Final Mitigation Plan Apple Valley Project

**DMS Project #: 100063 | Contract #: 7531 | USACE Action ID: SAW- 2018-01150
DWR Project #: 20181028 | RFP: 16-007334**

Re: NCIRT Review and USACE Approval of the NCDMS Apple Valley Mitigation Site / Henderson County / SAW-2018-01150; NCDMS Project # 100063

SUBJECT: Apple Valley Mitigation Site - NCIRT Comments during 30-day Mitigation Plan Review

Figure 10 - Monitoring Plan

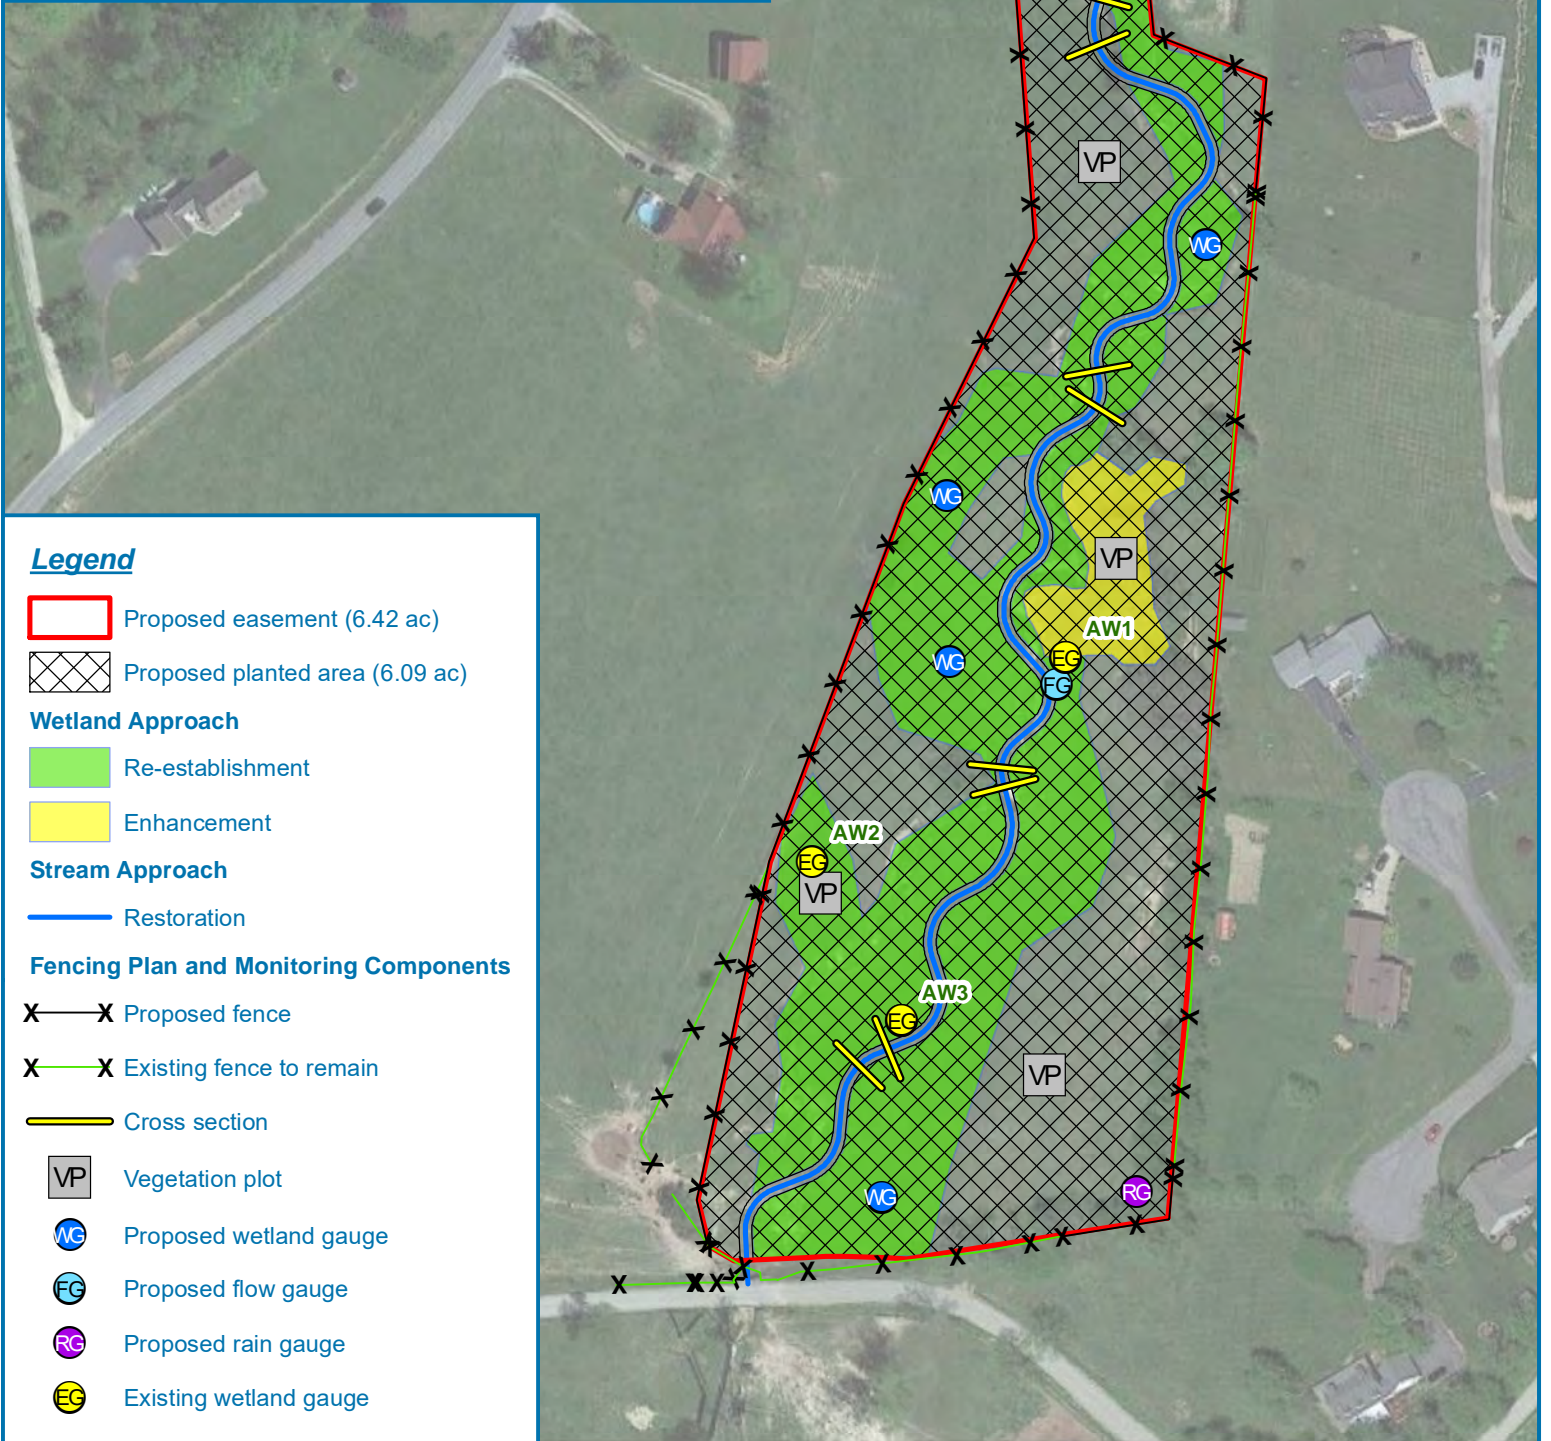
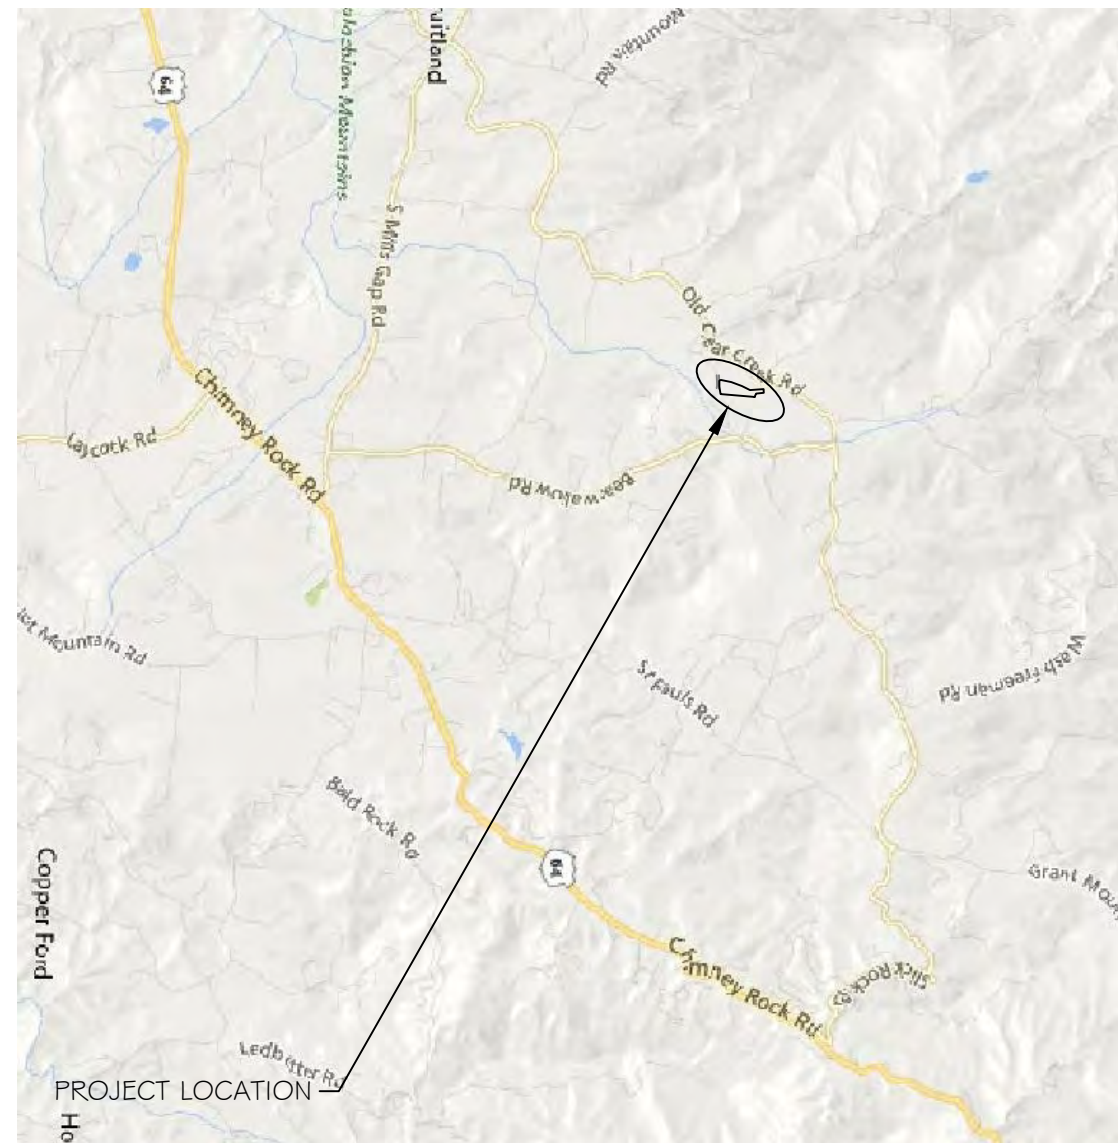
12. Figure 10 – DWR requests the installation of three (3) additional groundwater gauge, or relocation of either gauge AW2 or AW3 and installation of two (2) additional gauges. Recommended locations of new gauges are (1) in the wetland re-establishment area between the relic stream channel and proposed channel near Station 4+50, (2) in the wetland re-establishment area close to the western easement boundary between Stations 6+00 and 7+50, and (3) in the wetland re-establishment area close to the western easement boundary and veg plot between Stations 10+00 and 11+00.

12. Figure 10 – DWR requests the installation of three (3) additional groundwater gauge, or relocation of either gauge AW2 or AW3 and installation of two (2) additional gauges. Recommended locations of new gauges are (1) in the wetland re-establishment area between the relic stream channel and proposed channel near Station 4+50, (2) in the wetland re-establishment area close to the western easement boundary between Stations 6+00 and 7+50, and (3) in the wetland re-establishment area close to the western easement boundary and veg plot between Stations 10+00 and 11+00.
*Gauge AW2 has been moved and two gauges have been added to the suggested locations. **Figure 10 and Section 8.5** have been updated to reflect this change.*

DRAWING TITLE:
REACH AV1

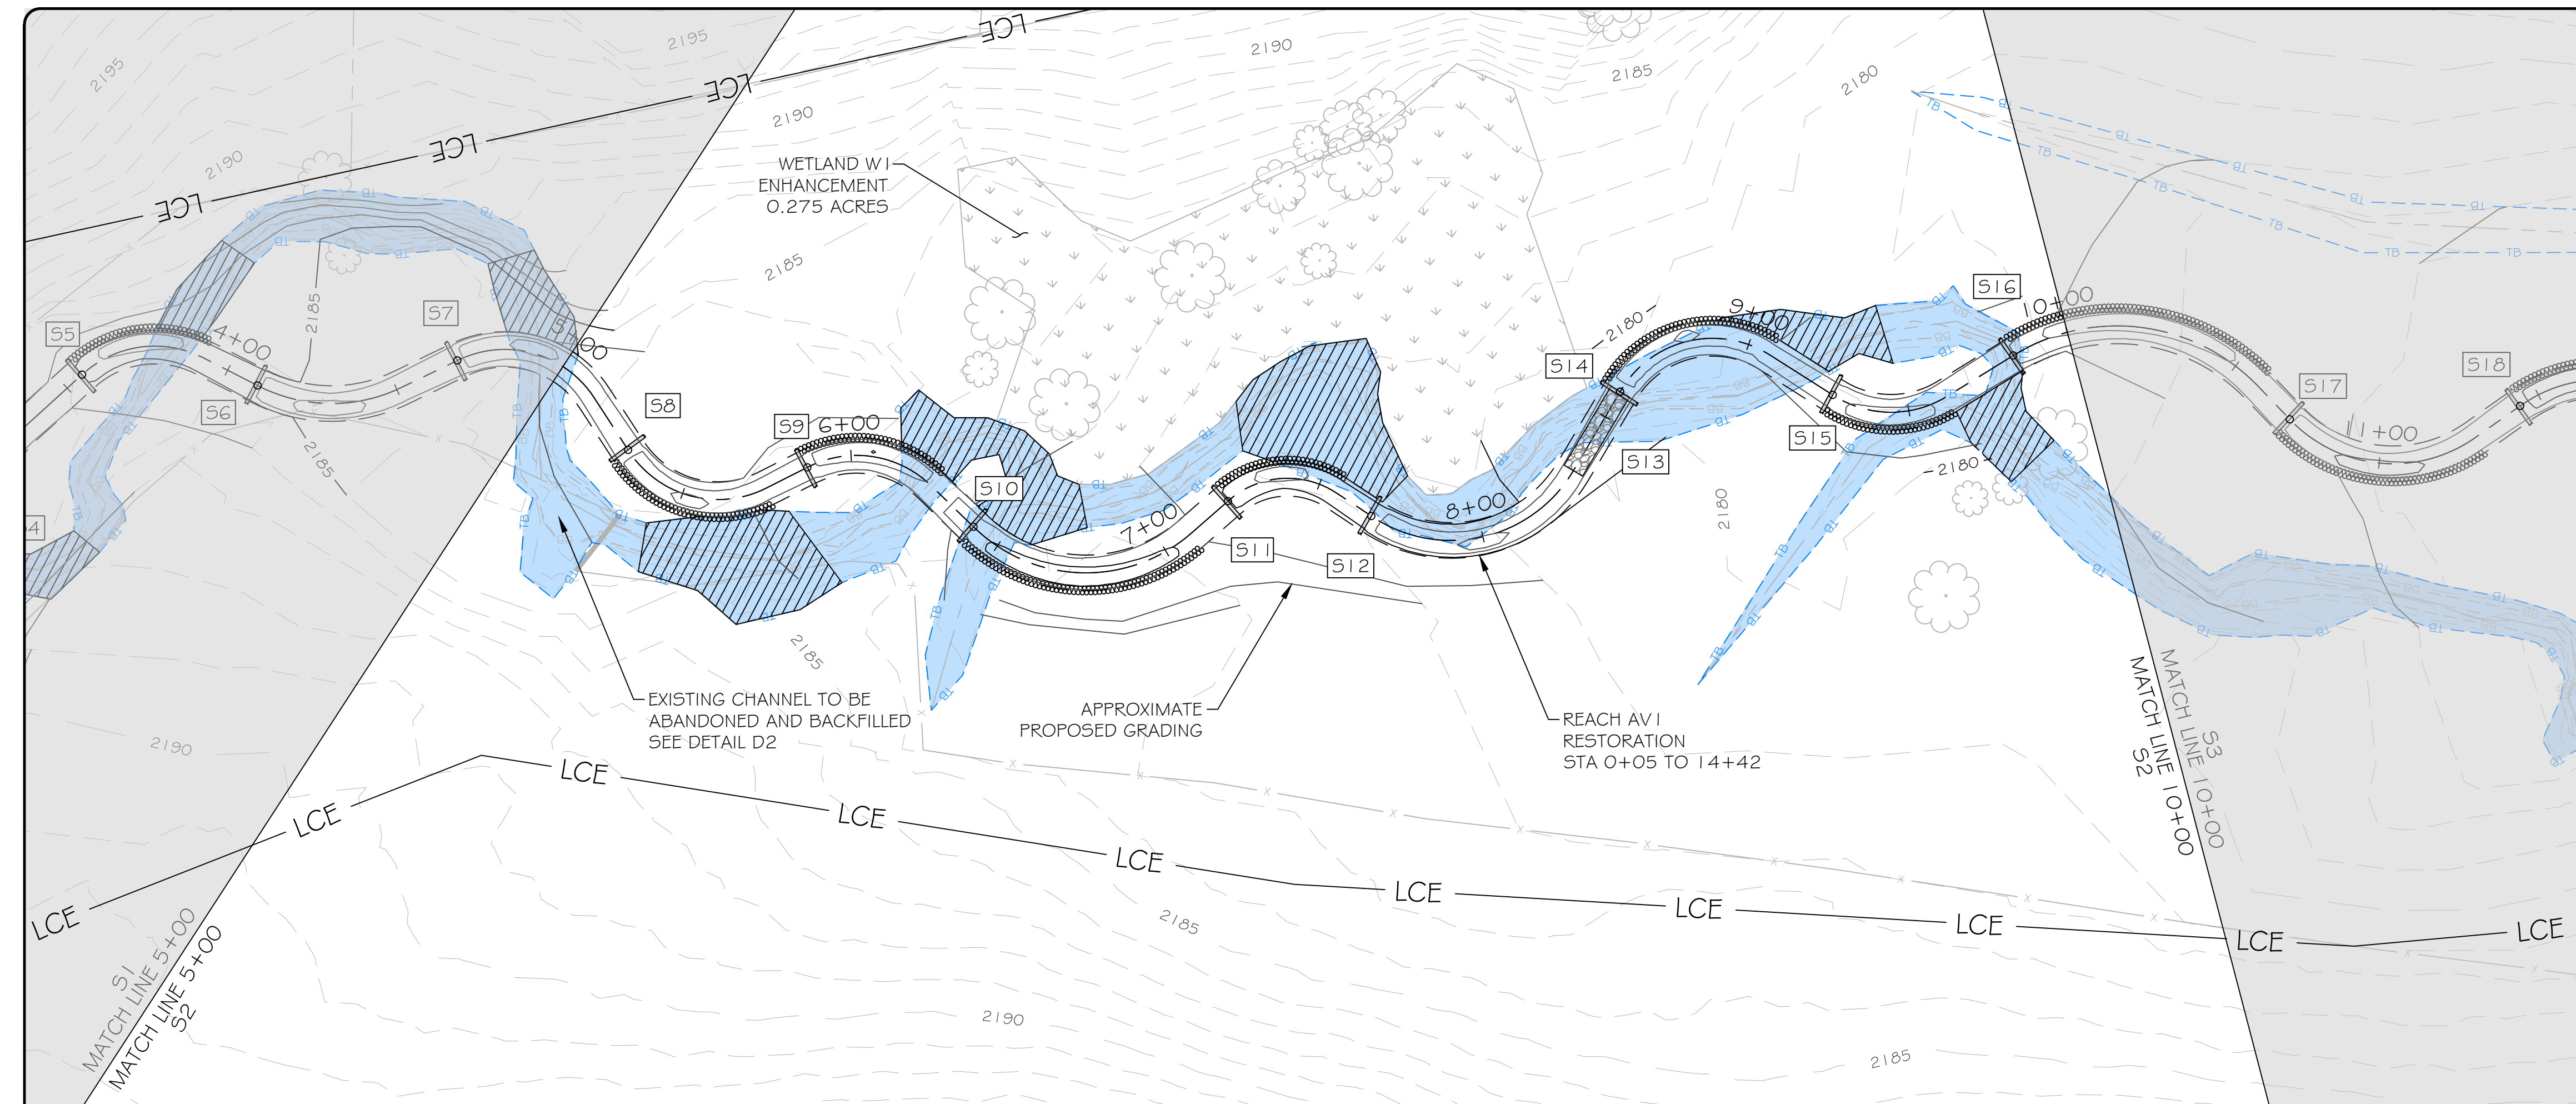
13. Sheet 1 – Please explain why no toe protection is proposed along the outer meanders near Stations 0+50 and Station 1+00 and why the benches are so narrow. The bench widths do not appear adequate and DWR is concerned about the long-term stability of this stream segment.

13. Sheet 1 – Please explain why no toe protection is proposed along the outer meanders near Stations 0+50 and Station 1+00 and why the benches are so narrow. The bench widths do not appear adequate and DWR is concerned about the long-term stability of this stream segment.

Sheet 1 has been updated with toe protection added to the outer meander bends near stations 0+50 and Station 1+00. Floodplain benching is not proposed on this project. Floodplain grading at the transition from the existing alignment at the top of the project is slightly steeper than the majority of the project, due to spatial constraints there, but entrenchment ratios remain well above 2.2.

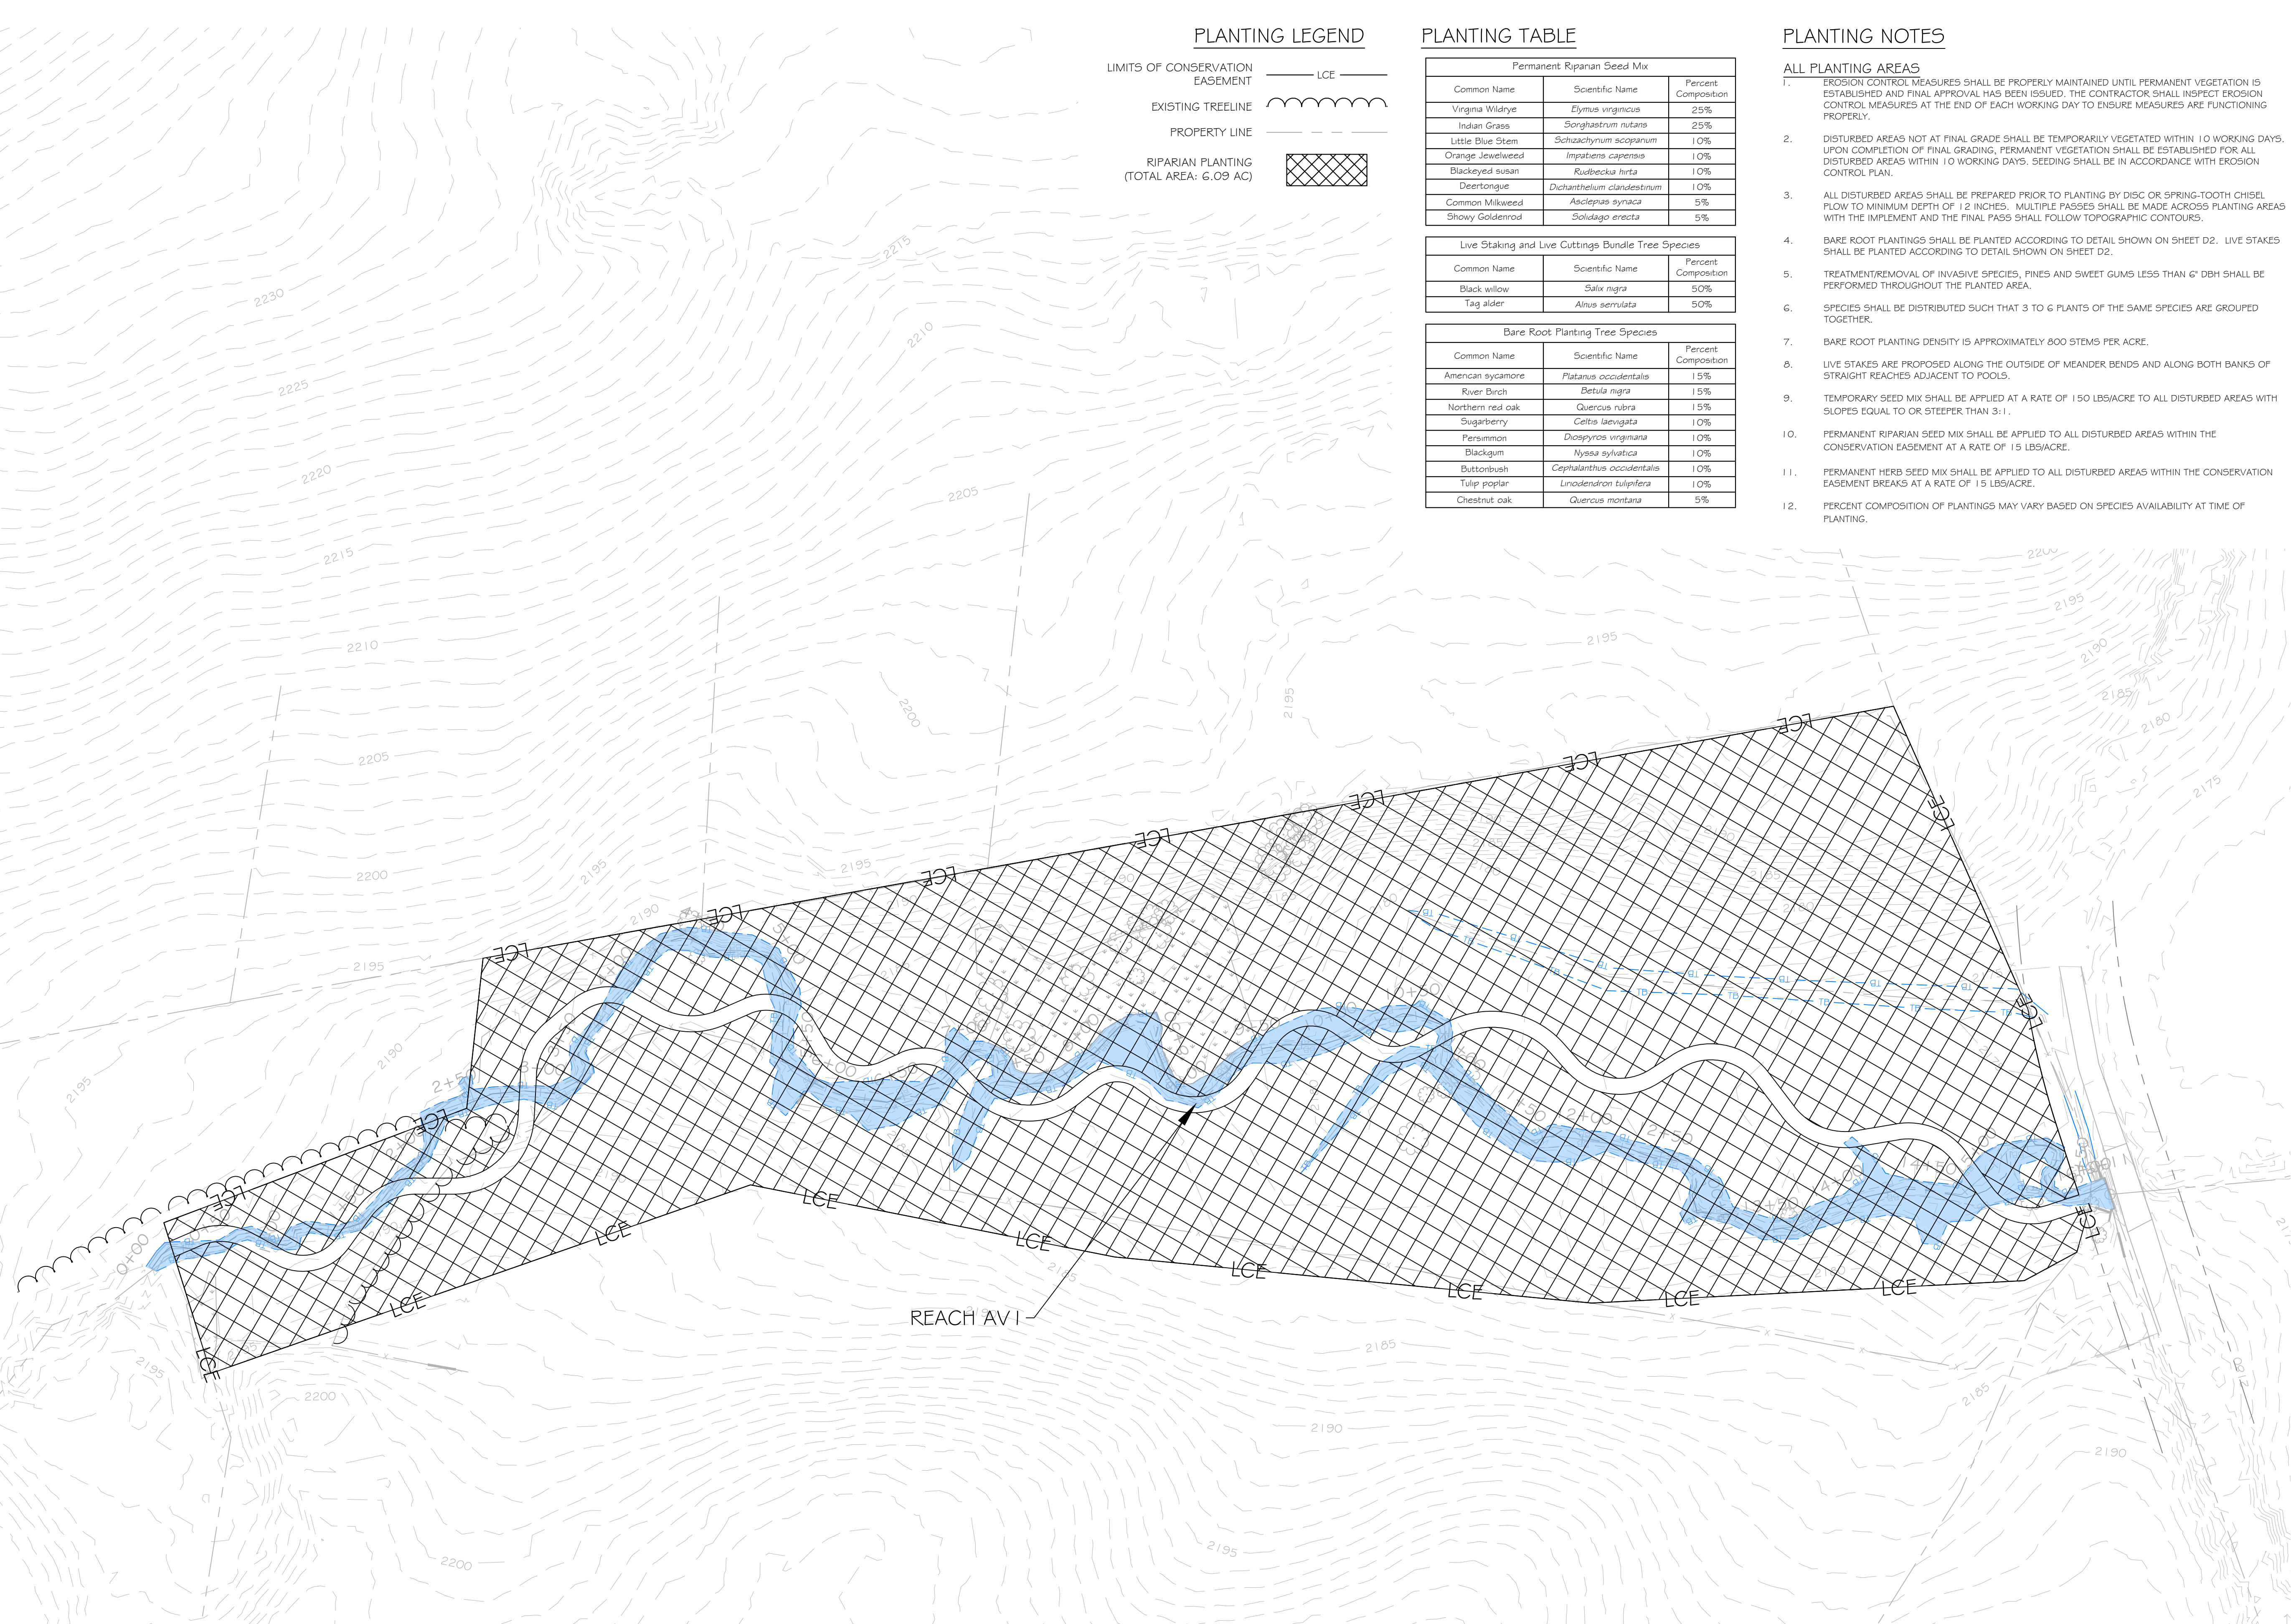
16. Sheet P1 – Please confirm that the Since *Juncus effusus* has a seed bank onsite, was an alternative species considered for the site seed mix?
17. Sheet D2 –

16. Sheet P1 – Please confirm that the Since *Juncus effusus* has a seed bank onsite, was an alternative species considered for the site seed mix?
*Juncus effusus has been replaced with *Impatiens capensis* in the proposed riparian seed mix. However, as the proposed mix may change based on seed availability at the time of construction if *Impatiens capensis* is not available at the time, another species may need to be selected .*
